# SERVICE BULLETIN

NO. 200-005

1. SUBJECT : Introduction of Teijin Seiki Service Bulletin No. TS-SB-72 (Inspection and Modification of Teijin Seiki Fuel Strainer P/N FIF-40000)
2. AIRCRAFT AFFECTED : All FA200-160, 180 and 180A aircraft equipped with fuel strainer specified by Teijin Seiki S.B. No. TS-SB-72.

NO. TS-SB-72      DATE 1-10-84  
REV                      DATE  
                            REASON

Fig.-2 STRAINER ASSEMBLY (before repair)

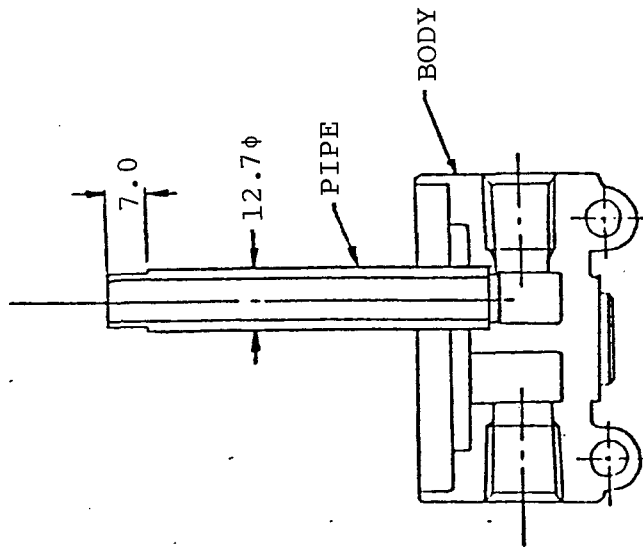
In connection with some particular model of FIF40000 Fuel Strainer, there is slight chance of its piece part; FIF40008 pipe becoming loose in the body, which might result in fuel-blockade.

- 1) Remove and discard lockwire from bolt (1).
- 2) Untighten bolt (1), tilt bracket (2) and remove cover (3), packings (4) (10), barrel (5), washer (6) and screen (7).
- 3) Check pipe and body as is in assembled condition, according to Fig.-1, to see if repair work is required by its configuration.
- 4) For pipe and body which have been determined to be repaired, further inspection shall be conducted as follows.
  - a. Check the interference fit area of pipe and body for looseness by pulling and pushing the pipe.

- 1) Remove and discard lockwire from bolt (1).
- 2) Untighten bolt (1), tilt bracket (2) and remove cover (3), packings (4) (10), barrel (5), washer (6) and screen (7).
- 3) Pull out pipe (9) from body (8).
- 4) Check and clean the hole in the body (8) and insert the replacement pipe (P/N FIF40020) into the hole by pressing or by tapping it with a plastic hammer, until a shoulder on the pipe comes in contact with the surface of body (8).  
Clean the parts. (Reference : Fig.-3)
- 5) Clean and reassemble the parts that have been removed in paragraph 2). Tighten bolt (1) to the torque of 15-20 IN.LBS.
- 6) Apply lockwire on bolt (1).

Phase 2 : The repair work is to replace the pipe with FIF40020 pipe.

Fig.-1

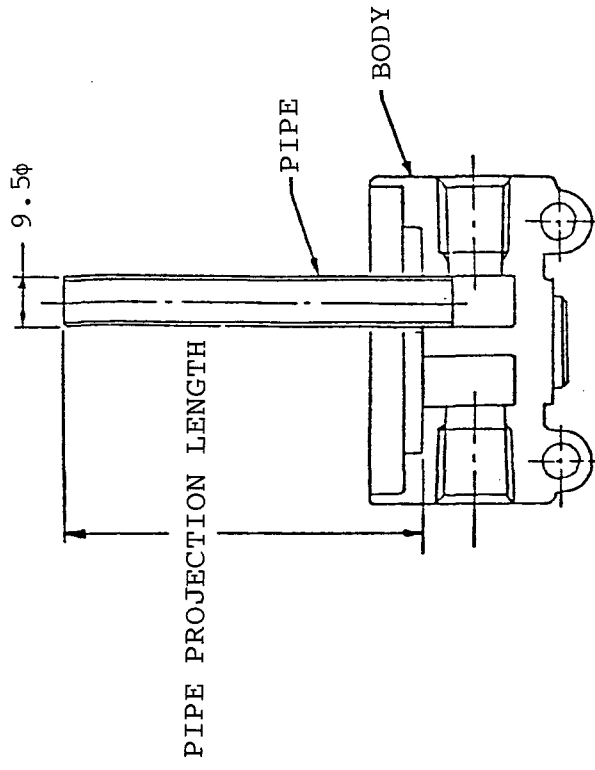
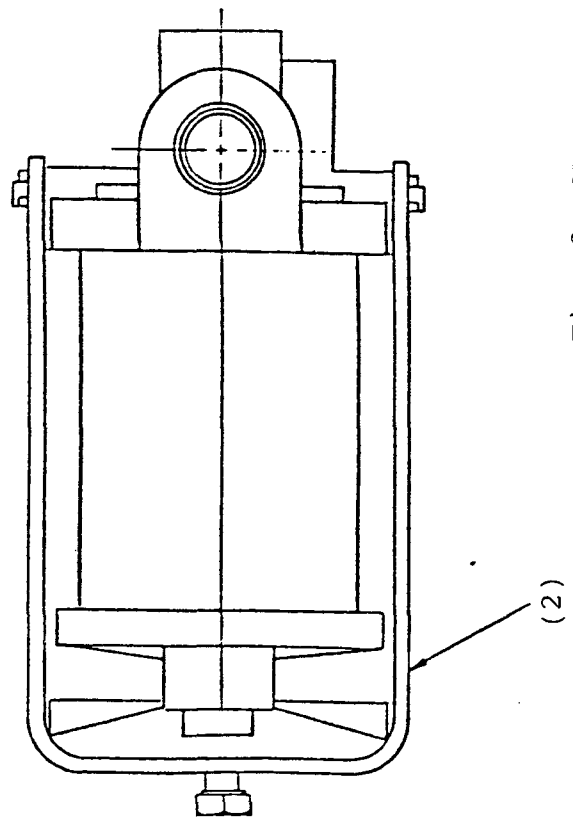
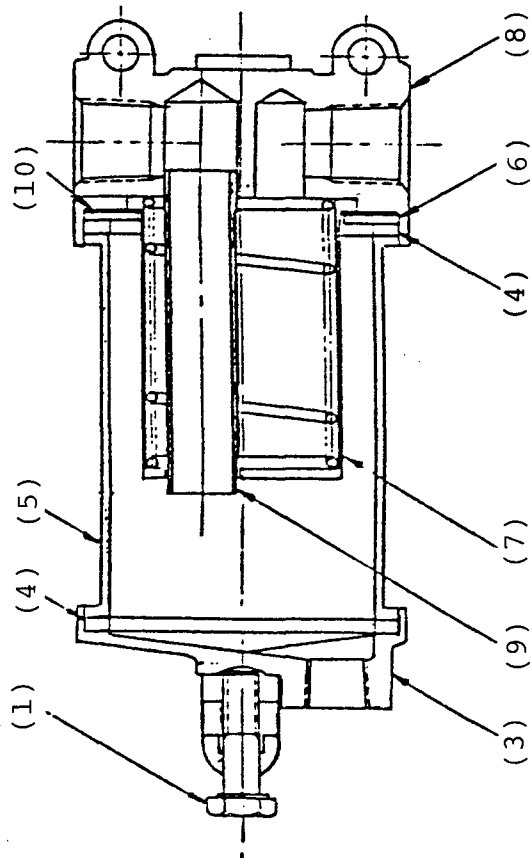
Phase 2 : All aircraft equipped with any of; Fuel Strainer of S/N before 444 inclusive, Fuel Strainer, to which repair work is required in view of its configuration as shown in Fig-1, among those of S/N 445 to 504 both inclusive, or Fuel Strainer S/N of which is unidentifiable.

Phase 1 : All strainers defined in paragraph 2 Phase 1 shall be inspected and determined by configuration whether repair work is required according to Fig-1.

Condition; loose pipe and/or pipe which projects less than 62mm from the surface of the body.

NOTE: Pull and push force shall be approximately 50g and no extreme force shall be applied.
  - b. Measure and record the pipe projection length.  
(See Fig.-1)

- 5) If the pipe is loose (moving up and down by above pulling and pushing procedure), and/or the pipe projection length is less than 62mm, Phase 2 repair work shall be accomplished before next flight.  
If there is not evidence of any of above condition, the strainer may be reassembled as per paragraph 7) and 8) for additional flight usage, but shall be

Strainer, repair work not required

Strainer, repair work required
